Focused Subsequent Environmental Impact Report for the UCP Update and VST Specific Plan

State Clearinghouse No. 2001021056

Merced County Community and Economic Development Department

July 2023

Figure 2-10 Water Master Plan

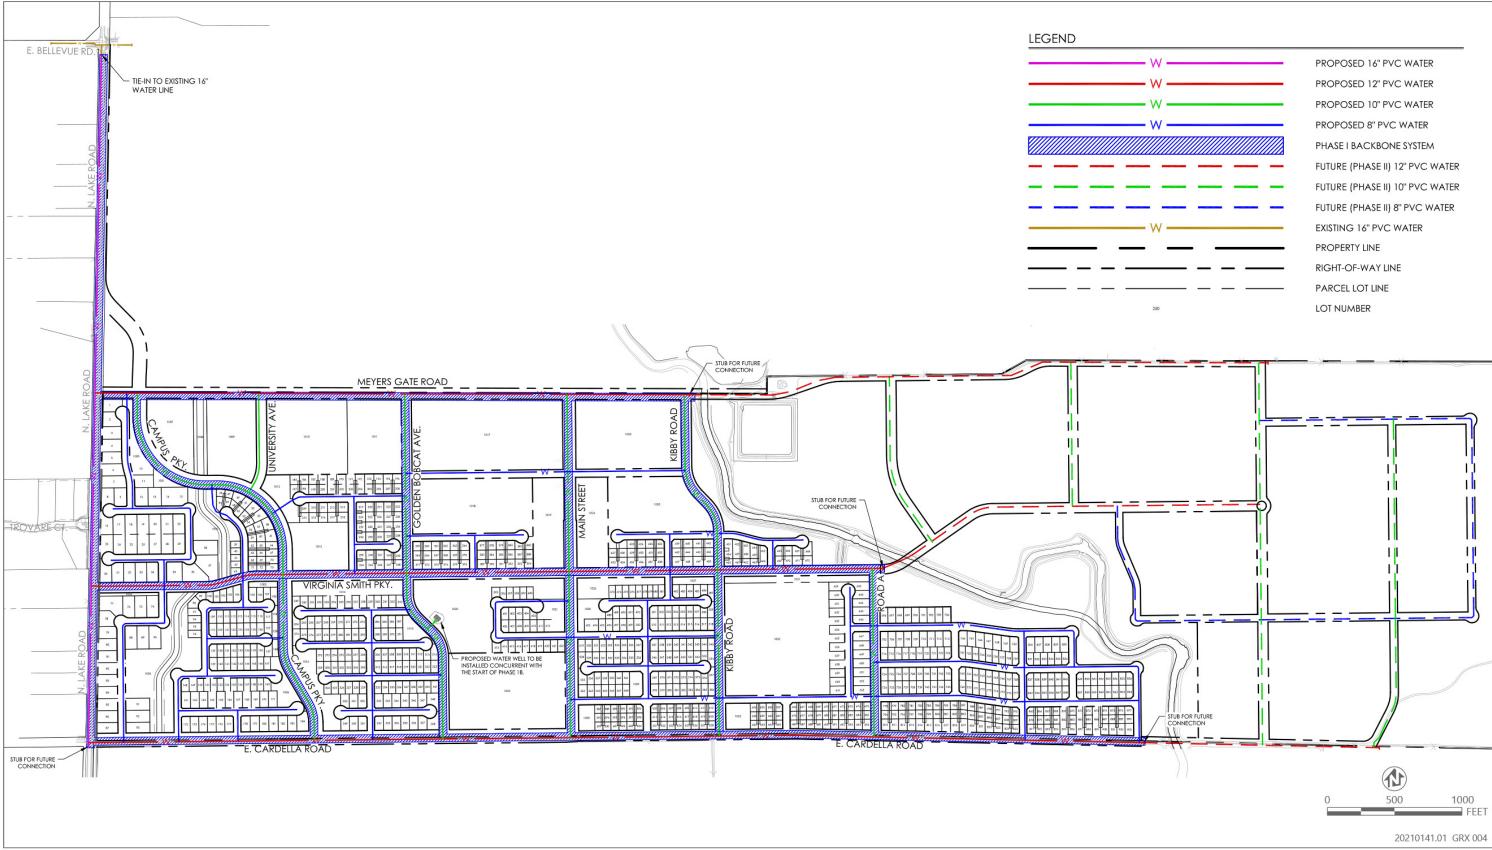
- Please include a clearer Figure 2-10 with a readable legend and labels.
- Please clarify if one new well (PDF page 340) or two new wells will be drilled (pdf page 258, three wells were considered in total). If two wells will be drilled, please include the second one on Figure 2-10 or another system infrastructure figure.

The comment requests that the text in Figure 2-10 of the Draft SEIR be revised for improved legibility. Figure 2-10 on page 2-33 of the Draft SEIR has been revised accordingly (refer to Chapter 3, "Revisions to the Draft SEIR"). This revision is made for the purposes of clarification and amplification of information in the Draft SEIR and does not constitute significant new information as described in CCR 15088.5; therefore, recirculation of the Draft is not required.

The text in Figure 2-10 on page 2-33 of the Draft SEIR has been revised for improved legibility. The revised figure follows.
